**RE: CORRECTIVE ACTION PLAN APPROVAL**  
**Case No. 2018-0559-AA**  
**Wiley H. Bates Middle School**  
**701 Chase Street, Annapolis**  
**Anne Arundel County, Maryland**  
**Facility I.D. No. 3200**

**Proposed Well Locations**

**Job Name:** Wiley H. Bates Middle School - Corrective Action Plan

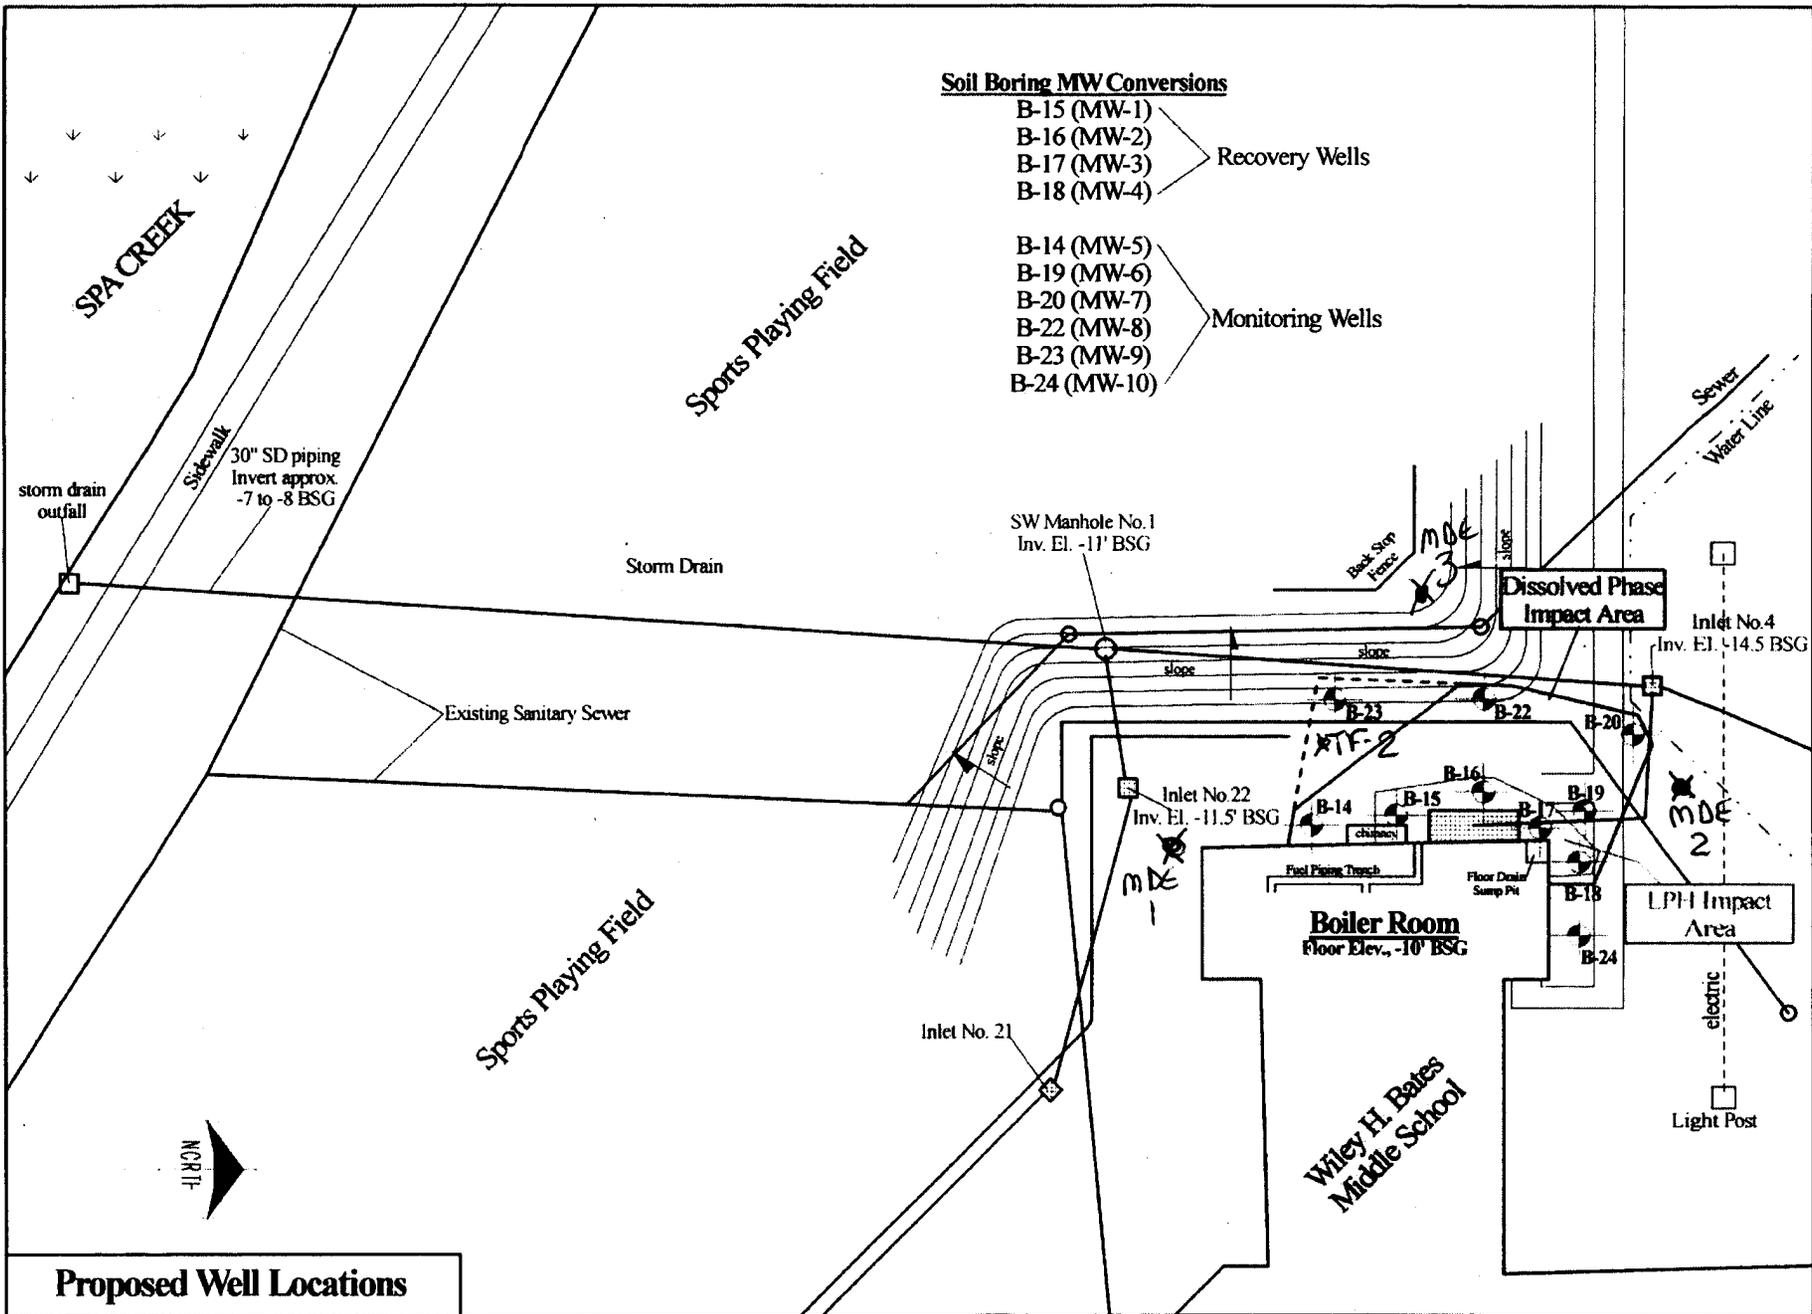
- c. The OCP requires the installation of 3 additional perimeter monitoring wells to monitor other potential migratory pathways. See the enclosed site map for these locations (MDE-1, MDE-2 and MDE-3).

- d. The OCP requires the installation of an additional tank field monitoring pipe in the southwest corner of the active UST field. This pipe must be installed just outside the tank field backfill material to prevent damage to the active UST system during installation. This well must be installed at least 5 feet below the water table (approximately 18 feet) (see enclosed map). The OCP suggests shifting proposed "B-23" to meet this requirement.
